Re: Request for Additional Information  
Docket No. 030-36971  
License No. 09-23920-01E

The following is a response to your request for additional information. Each response is enumerated per your questions.

**A. Information required for review of Sealed Source and Device amendment application.**

**B. Information required for review of exempt-distribution license amendment application**

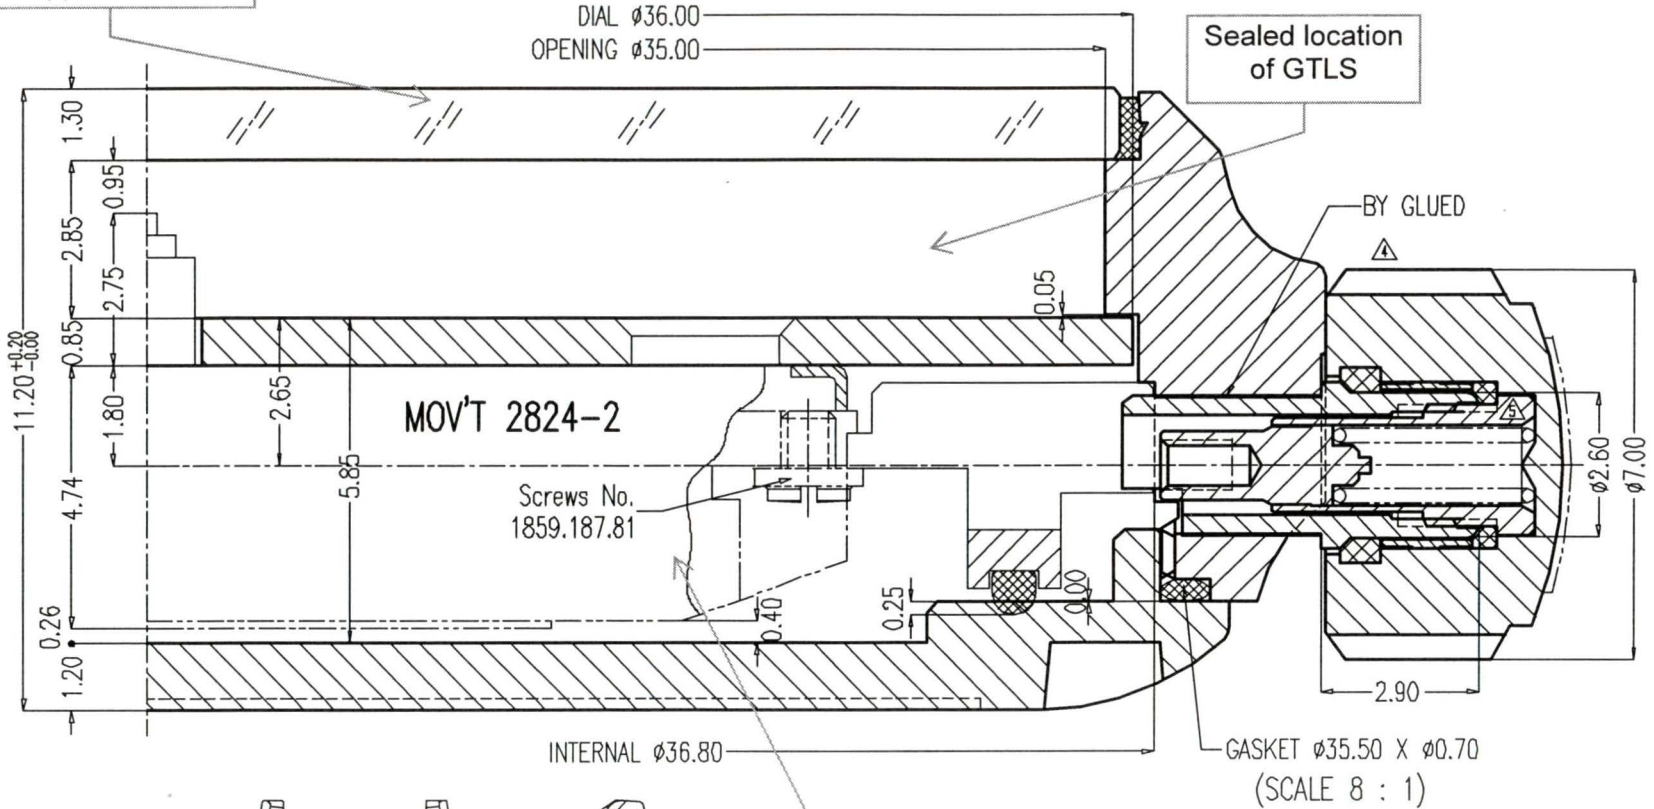
1. Attachment "B" is a cross section of the timepiece. The crystal is constructed of sapphire glass. The sapphire glass is permanently sealed to the bevel encasing the GTLSs. The only accessible part of the timepiece is through the underside which will allow access to the mechanical movements of the timepiece. Access to the underside requires specialized tools and is not a function of normal operation or use of the timepiece.

For all GTLS tubes to simultaneously rupture would require a destruction of the timepiece crystal. The timepiece crystals are sapphire. Sapphires (also known as Corundum) have a hardness of 9 on the Mohs scale. Sapphires are mechanically second only to a diamond which has the maximum hardness of 10 on the Mohs scale. Sapphire glass is one of the hardest and most scratch resistant materials available. The high modulus of elasticity and high tensile strength make it extremely wear, abrasion and impact resistant.

Sapphire glass is thermally very stable. It does not lose any of its mechanical and optical qualities from temperatures ranging from cryogenic to over 2000C. There is no surface damage and devitrification due to extreme thermal cycling. Sapphire glass is more resistant to corrosive chemicals than most standard hard materials available.

Even in the event all GTLS tubes becoming damaged, the H-3 would still be sealed between the sapphire crystal and hardened steel which has a hardness of 7-8 on the Mohs scale.

CUSTOMER: BALL	MODEL: 3775GS-C	DRAWER: Deng
YOUR MODEL: NM1092C		DATE: 2007-03-31
MOVEMENT: 2824-2	A T M: 10	13 PAGES
		CHECKER:

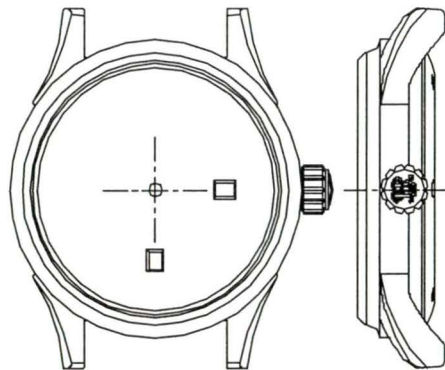
1. Model NM1092C is the proper and complete designation for the model timepiece.
2. Model NM1092C will have a maximum activity of 102.3 mCi (3.79 GBq).
3. See Attachment "A". The location will be on the lower face of the timepiece.
